Access Compliance Report Public Rights-of-Way (Curb Ramps)

Main Street: CASTOR_CT		Cross Street: COMET_TRAIL		Location:	W
ADA ID: RPAT211101103655	Ramp Type: Type 4 - Parallel	Initial Pass/Fail: Fail	Overall Compliance: No	Severity Score:	2
Codes/Mitigation Info/Possible Solution			Field Measurements/Component Compliance

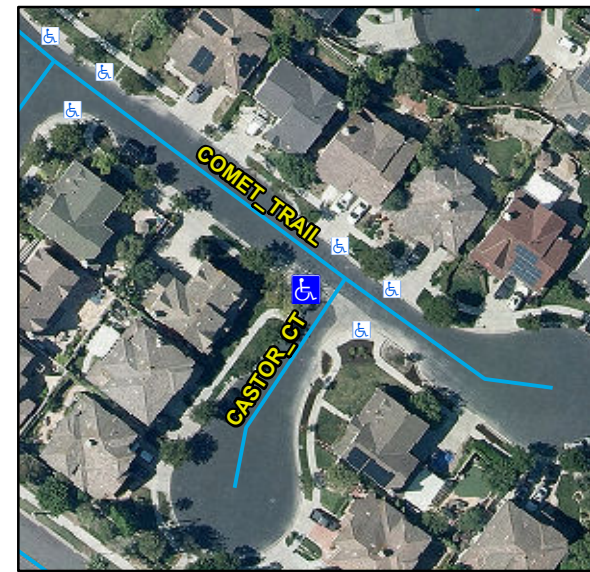
R304.2.2, R204.3, R304.5.3, STD 1115

Remove & Replace Curb Ramp With Two New Directional Ramps or Equivalent.
